What We Heard Report

Round Two of the Public Engagement for Indigo Shores Park Planning

June 2023

HALIFAX

Concept Plan Presented for Midnight Run Park

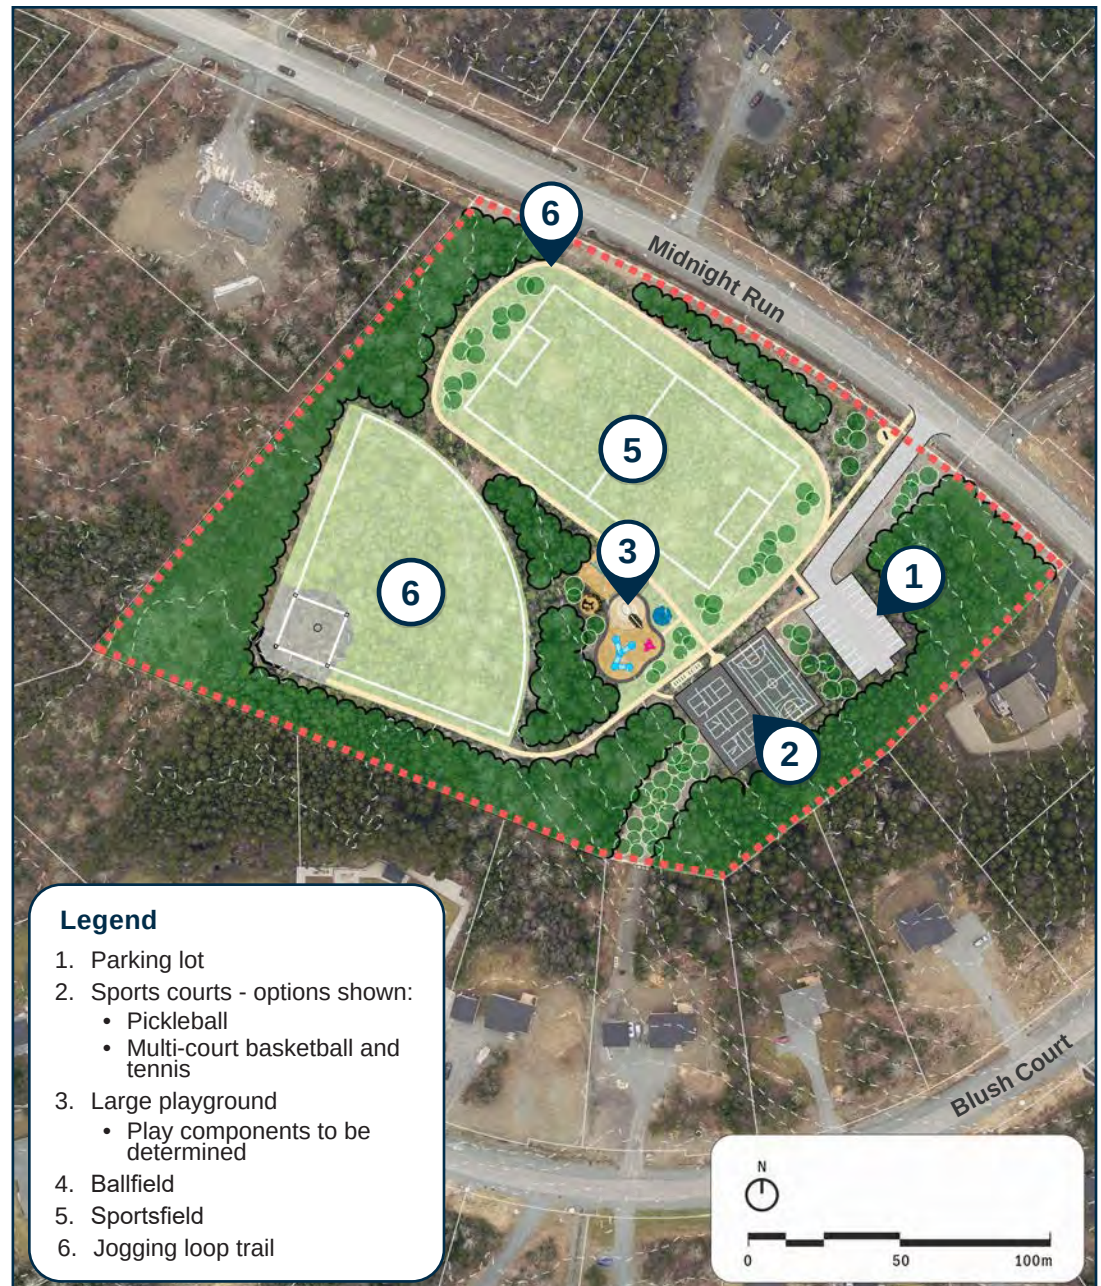
While the proposed concept for Midnight Run Park received positive feedback, several visitors to the public open house expressed concern about the proposed plan. Specifically, residents were worried the park would be noisy. Many participants with properties neighbouring Midnight Run Park were nervous that removing the existing vegetative buffer would raise privacy concerns and create undesirable views from their properties into the park; many residents would prefer if the buffer surrounding the parkland remained intact.

Due to the number of proposed amenities, several participants were concerned by the size of the proposed parking lot. Respondents noted that the playing fields - specifically the ball diamond - would draw in residents from surrounding communities who would be likely access the amenity by car.

Additionally, survey participants expressed concern that insufficient parking would lead to parking on the side of the road on Midnight Run, leading to increased traffic and potentially dangerous situations for pedestrians and cyclists trying to access Midnight Run Park. Many participants stressed the importance of including additional parking in the final park plan.

Similar to comments heard during the open house, many respondents were concerned about the increased noise levels park amenities may cause. Several respondents said that park amenities would

lessen the appeal of the neighbourhood, as many residents like living in Indigo Shores because of the subdivision's tranquil nature. Like open house attendees, survey respondents would like to see the existing vegetative buffer surrounding the parkland preserved to buffer noise and views of the proposed parkland.

Respondents also noted that the addition of destination amenities, specifically ballfields, would cause an increase of on-street parking, non-local traffic, and members of recreational leagues using the park after hours. Several participants also said the ball diamond's lighting would be disruptive.

Conversely, numerous participants also felt there were too many proposed amenities. Feedback included comments about how the proposed amenities would cause the removal of existing vegetation, an increase in non-local traffic, littering, and partying.

There was some disagreement about locating a sole playground for the community in Midnight Run Park. Many respondents felt it would bring the community together and offer a place for parents and their children to meet; other respondents said

the distance would be too far to travel by foot and was only accessible by driving.

"...[there is only] around 25 parking spaces, this will not be enough for the amount of amenities proposed."

Concept Plan Presented for Azure Court Park and Gaspereau Court Park

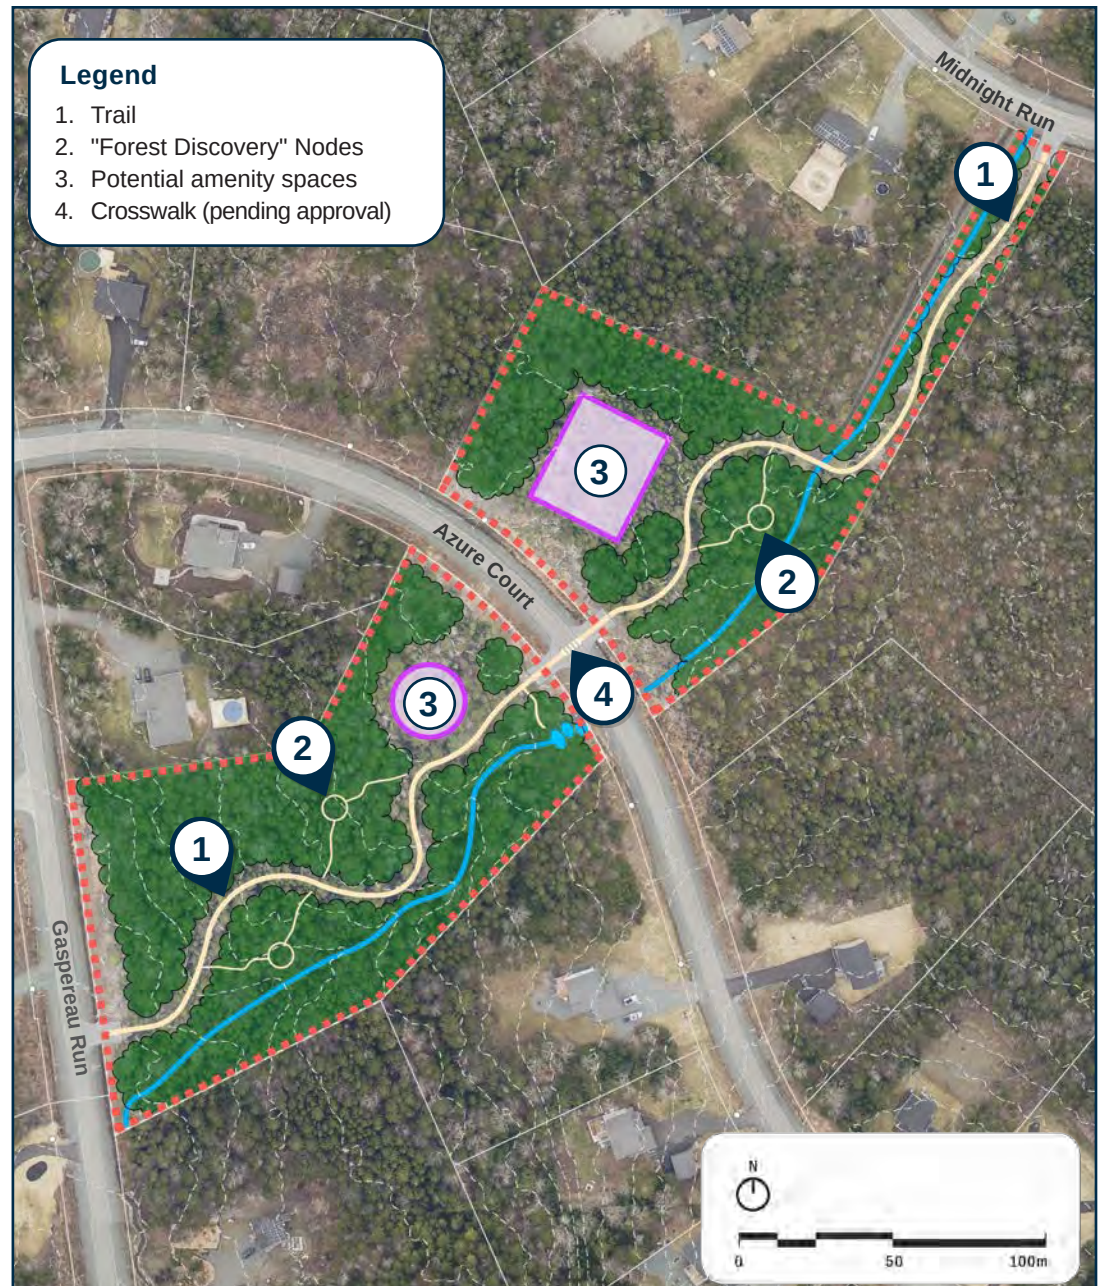
Survey participants liked the trail connectivity proposed in the concept plan and said the proposed trail would make the neighbourhood more walkable. The lack of sidewalks in the subdivision has led many residents to feel unsafe as pedestrians; many respondents said they would frequent the trail frequently to access different parts of the subdivision without having to walk or bike along the shoulder of the road.

Some respondents said they would like the trail to be paved to better accommodate biking, roller blading, and jogging in the community.

Though participants supported the proposed trail system, they were worried the secluded nature of the trail would lead to vandalism. Respondents noted the inclusion of garbage bins would be beneficial in reducing the amount of litter in the future park space.

Respondents said the success and overall use of the park would be determined by how the potential amenity spaces were eventually programmed. Several participants noted that the park may be hard to access in the amenity spaces were desirable, as there is not space allocated for parking. The most requested amenity was a small playground.

Several participants would like to see the parks' natural setting preserved. Many noted that these

parks were the more likely to have wildlife compared to other parkland parcels. Respondents would like to see the parkland left as close to its natural state as possible, and would prefer one amenity space rather than multiple to preserve as much forested area as possible.

Several respondents noted said they would frequent the trails with their dogs. Some respondents requested that the trails be off-leash, while others said the amenity space could be used for a fenced-in off-leash area. Participants suggested a dog park would be a good place to meet other dog owners in the neighbourhood and socialize their dogs.

Concept Plan Presented for Unnamed Park 22

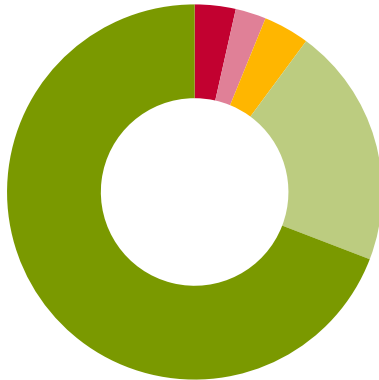
Open house attendees were concerned about alterations to the riparian zone, as a significant amount has already been removed along the lake's shoreline. Additionally, many expressed concern about rising temperatures and lake levels - especially as it relates to lake health and the potential for algae blooms in the future. Several participants stressed that water health must be monitored for pH levels if additional recreational activities are being proposed to ensure the health of McCabe Lake and its users.

"I agree with giving access to the lake. I wouldn't want to see a large number of trees cut down. The park would lose its appeal. Perhaps the parking is okay, but the less tree clearing the better."

"The water level here is very low during the late summer months. I worry about the privacy of neighbouring lots. The changing stall is a nice touch as long as the city maintains it. I wouldn't want to see anyone take advantage of this space (drugs, drinking, etc.)."

Many respondents were concerned about the changing stalls proposed by the concept plan. Many participants stressed that the unsupervised changing stalls would be a target for vandalism and become a hang out spot for teenagers. If changing stalls were implemented, respondents would like to see frequent visits from park staff to ensure they are properly maintained.

Additionally, many participants suggested a change stall was insufficient and requested a washroom facility instead. The inclusion of a washroom facility

Several respondents mentioned the distance from the parking lot to the shoreline at Unnamed Park 23 is too far to comfortably carry a kayak or canoe; many said they would be more likely to use Unnamed Park 22 due to the relatively shorter walking distance from the drop-off area to the shoreline. However, some participants felt the distance still too far and the proposed road should be lengthened for easier access.

Survey participants and Open House attendees expressed concerns about the possibility of people using the proposed boat launch to access the private island across the channel. Past incidents of littering and fires on the island have already caused

concern. Respondents worry the provision of a boat launch would increase accessibility to the island and exacerbate issues, ultimately leading to a greater number of future occurrences.

Participants were worried that a public open space with access to the water would become a popular hangout spot for teenagers and young adults at nighttime. Additionally, many were worried the proximity to the water would cause safety issues related to unsafe boating conditions and increased noise from sounds travelling across McCabe Lake at nighttime. Respondents expressed a desire for fencing and park hours to ensure cleanliness, privacy and the protection of neighbouring properties.

Several participants also commented on the lack of parking proposed in the concept plan. Respondents worried that lack of parking space would lead to visitors parking along the roadside and cause safety concerns for vehicular traffic and pedestrians.

Concept Plan Presented for Unnamed Park 23

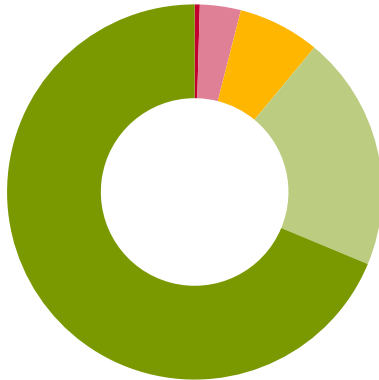
Survey respondents and open house attendees were concerned about the location for the proposed boat launch, as the lake level is significantly lower in this area during the summertime. Several participants suggested that the boat launch be relocated closer to the swimming area.

Many survey participants expressed enthusiasm for the proposed swimming access. Currently, the swimming access for Unnamed Park 23 is rocky and difficult to use. Many respondents said they would be likely to use this area for swimming if the beach were groomed and access was improved.

The comments regarding the proposed change stall were similar to comments left for the other park plans where changing stalls are proposed. Many respondents discouraged the proposed amenity, suggesting they were likely to become a hangout spot and a target for vandalism - especially if left unsupervised.

Respondents were favourable to the proposed boardwalk. Several noted they would appreciate the longer walking trail the proposed boardwalk provides.

"The boat launch is a poor location... I have lived here for years and the water level drops too low nearly every year in this location. The boat launch should be moved to the #6 area."

"A changing stall would be an eyesore and an invitation for potentially inappropriate behaviour. It would also likely be a target for vandalism."
